Industry/TSTF Standard Technical Specification Change Traveler

Revise LCO 3.5.5 for RCP seal injection flow resistance

NUREGs Affected: 1430 1431 1432 1433 1434

Figure 3.5.5-1 (page 1 of 1)
Seal Injection Flow Limits

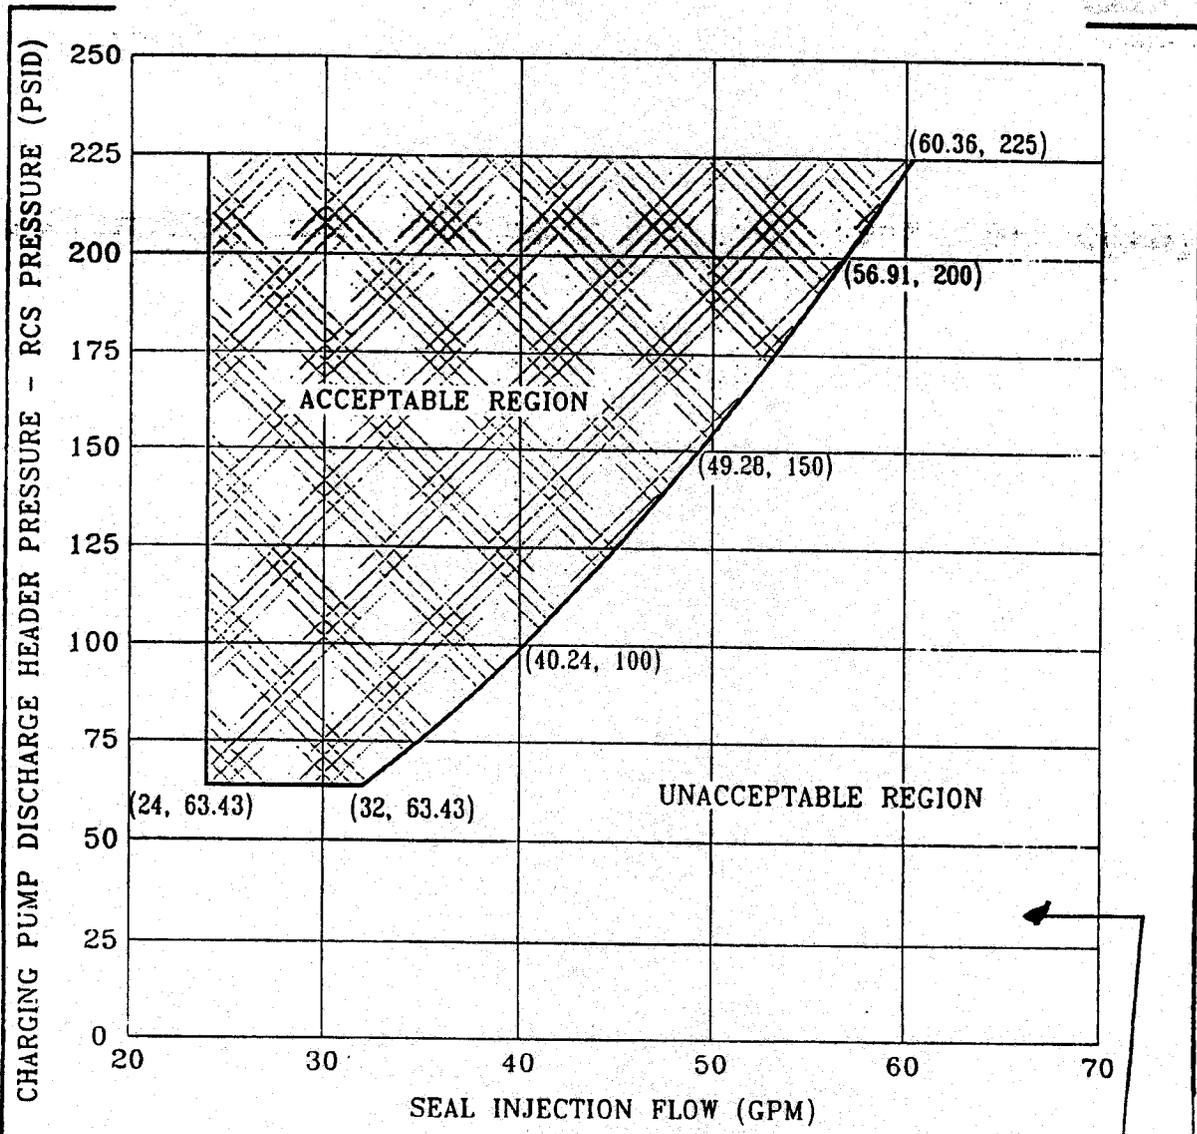
"Reactor coolant pump seal injection flow [resistance] shall be \leq [40] gpm with [centrifugal charging pump discharge header] pressure \geq [2480] psig and the [charging flow] control valve full open or \geq [0.2117] ft/gm² or within the limit of Figure 3.5.5-1."

Change Description: Added Figure 3.5.5-1

The LCO is not strictly a flow limit, but rather a flow limit based on a flow line resistance. In order to establish the proper flow line resistance, a pressure and flow must be known. The flow line resistance is established by adjusting the RCP seal injection flow in the acceptable region of Figure 3.5.5-1 at a given pressure differential between the charging header and the RCS. The centrifugal charging pump discharge header pressure remains essentially constant through all the applicable MODES of this LCO. A reduction in RCS pressure would result in more flow being diverted to the RCP seal injection line than at normal operating pressure. The valve settings established at the prescribed centrifugal charging pump discharge header pressure result in a conservative valve position should RCS pressure decrease. The flow limits established by Figure 3.5.5-1 ensures that the minimum ECCS flow assumed in the safety analyses is maintained.
